Comments on the Response to my Code Appeal by David Miles Ziskind of STV Architects

STV's response was submitted to the New York State Board of Review on November 3, 2020 and forwarded to me via email by Thomas DiTullio of the DBSC on November 17, 2020.

Prepared by Jonathan Ochshorn
Date: November 23, 2020

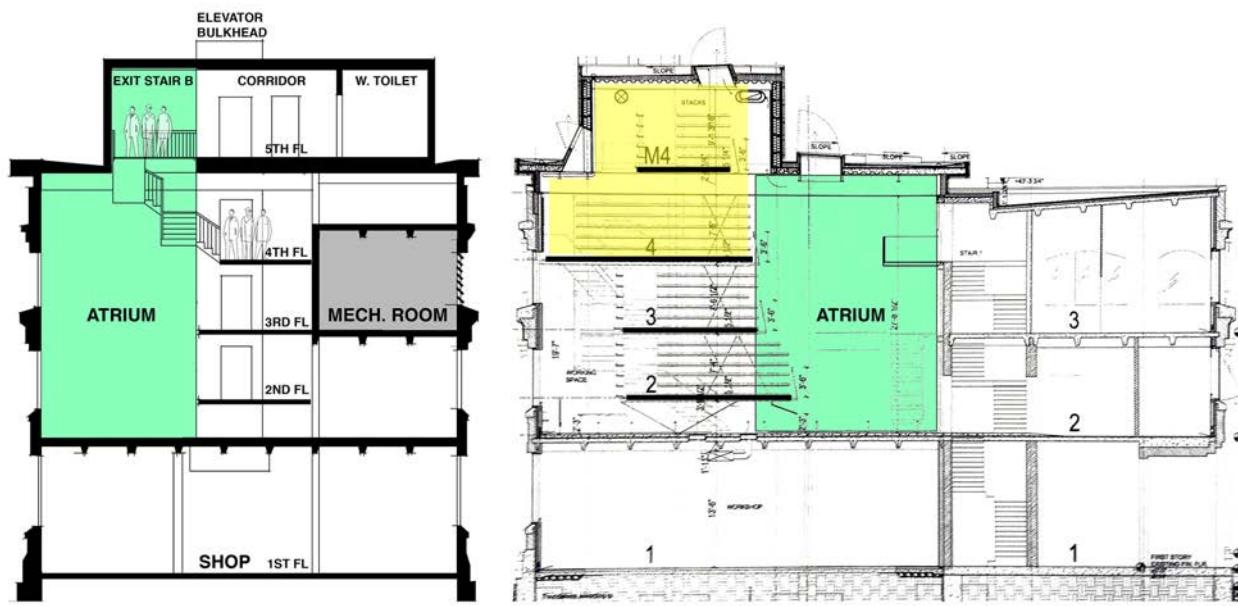
The roof-top story in question is not a mezzanine, and so meeting the two criteria listed in Section 505.2.3 is not relevant. Only a *mezzanine* that meets either of the two criteria in Section 505.2.3 can forgo being open and unobstructed to the room in which it is located. Of course, it is possible for numerous rooms or spaces in a story to either have an occupant load not greater than 10, or to have two or more exits: meeting either criterion does not magically turn such rooms or spaces into mezzanines. If that were the case, then every bathroom with low occupancy and every assembly room with two exits would be a mezzanine—a proposition that is obviously absurd. To invoke this section, the architects would first have to demonstrate that the space in question would meet the definition of a mezzanine if it were open to the room in which it is located. But this roof-top enclosed space is not even located "in a room" at all. It is clearly built directly on top the roof structure defining the ceiling of the fourth floor; in other words, it constitutes a fifth story.

It is possible for a mezzanine to adjoin an atrium, for example, if it is within the floor and ceiling of a double-height room or space adjoining the atrium. Such a hypothetical arrangement is shown in Exhibit 2, page 9 (right image) and also occurs in the Rand Hall 100% design development drawings from November 2016 that show a building configured with four-stories and a mezzanine within the fourth floor. In Appendix Figure 1.2 shown below, the current scheme (left), with an atrium but no mezzanine, is compared with this unbuilt scheme from 2016 (right). The unbuilt scheme from 2016 has a legal mezzanine; the current scheme does not.

Appendix Figure 1.3. Smoke hatches form the northern boundary of the roof-top art gallery assembly space.

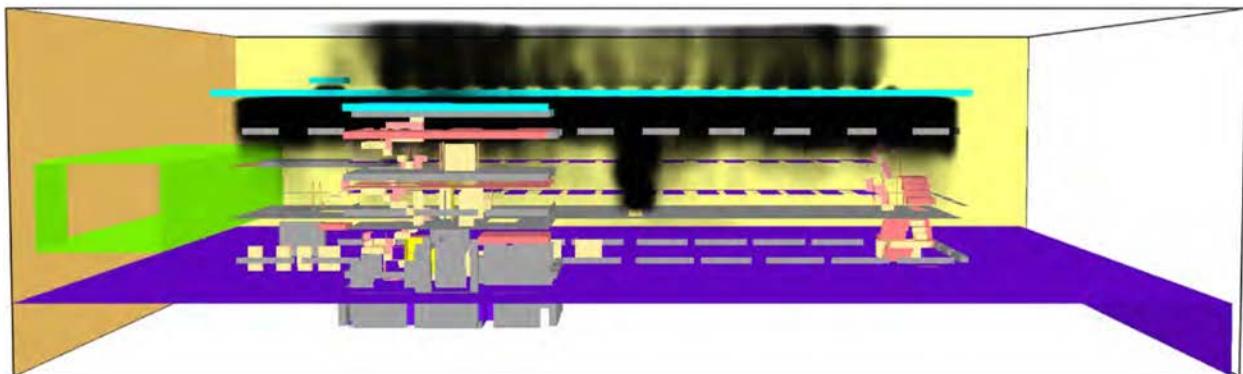
- b. The smoke being exhausted from the smoke exhaust vents does not pose a threat to the rooftop occupants. Smoke passing by the occupants in an exterior space does not threaten to accumulate as there are no obstructions on the roof to maintain a smoke layer that would compromise tenability. Also, the smoke being exhausted from these vents is being pushed upward with a force and speed from the fire and the makeup air being provided in the atrium space.

It is disingenuous to claim that smoke released immediately adjacent to an occupied roof deck, and precisely at the level of the roof deck, would not present a hazard to art-gallery occupants during a fire event. Unpredictable and variable wind directions and wind pressures, especially prevailing winds from the north and northwest, can blow toxic smoke exhausted from the roof hatches directly south onto the open art-gallery space. These exhaust hatches were designed for the roof *before* an art gallery was envisioned for the roof-top space, and the architects and their consultants never bothered to substantially revise the smoke exhaust design geometry when an add-alternate for the art-gallery was ultimately included in the project. The art gallery assembly space is literally bounded by these smoke hatches on its northern edge, as can be seen in Appendix Figure 1.3 below.
